Illustrated Parts List - IPL Update

H395 XP H395 XP EPA

Tank cap assy

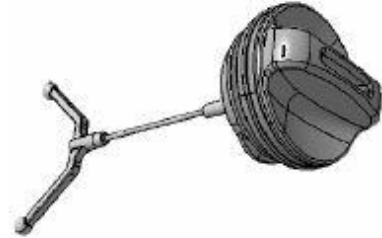
1. Tank cap assy. New material specification and supplier
2. New Handle Kit, wrap available.

537 21 52-07

537 21 52-02
